**Submission in regards to DA2023/0130 Development Application  
109A Church Street, Lidcombe**

*“Demolition of existing buildings and construction and operation of an organic waste transfer station. Integrated Development - Section 43(b) of Protection of the Environment Operations Act 1997. The proposal is Designated Development under the provisions of the Environmental Planning and Assessment Regulation 2021.*

**Figure 4** – Recommended 4.5m wide deep soil lawn location

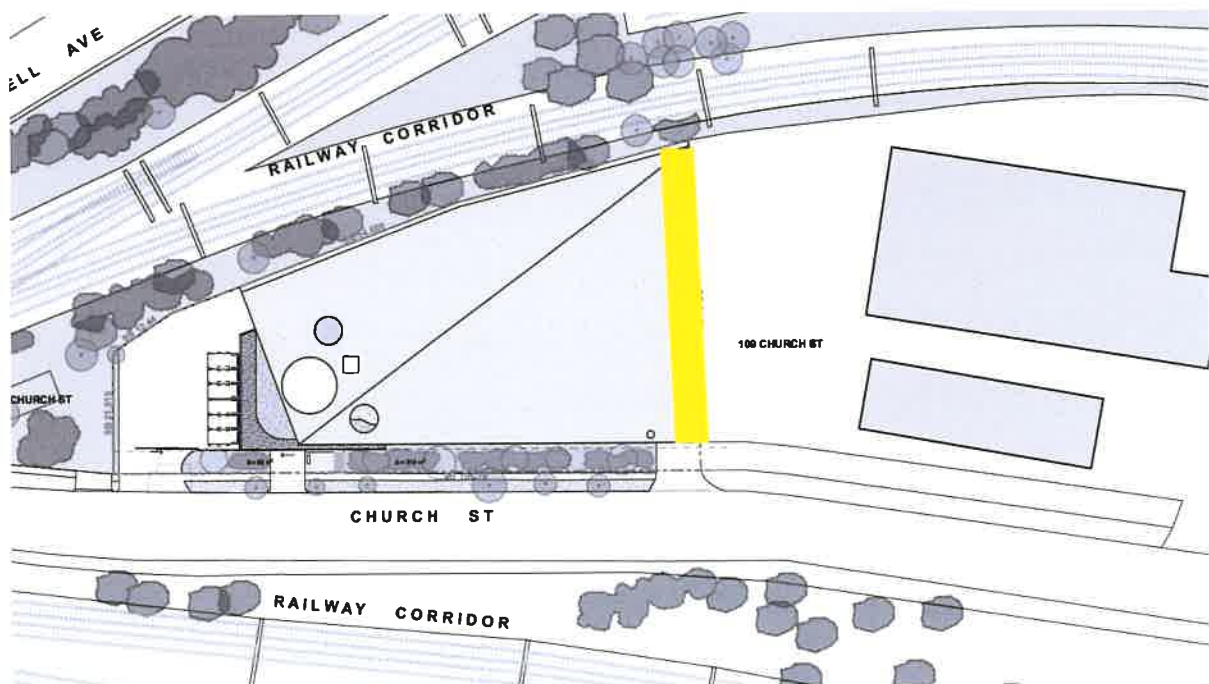
A 4.5m minimum landscaped side setback with lawn should be applied along the eastern boundary as per figure 4 to:

- Provide visual relief for users of No. 109 and members of the public walking along Church Street who can easily see this elevation from the footpath.
- Reduce the likelihood of new works at 109A causing structural issues for the retaining wall and boundary of 109 Church Street.
- Assist with stormwater drainage management, minimising adverse overflow impacts on 109 Church Street.
- Reduce noise and odour impacts for 109 Church Street.

No trees or hedges should be planted within the setback as these may pose structural damage to the retaining wall and future structures at 109 Church Street.
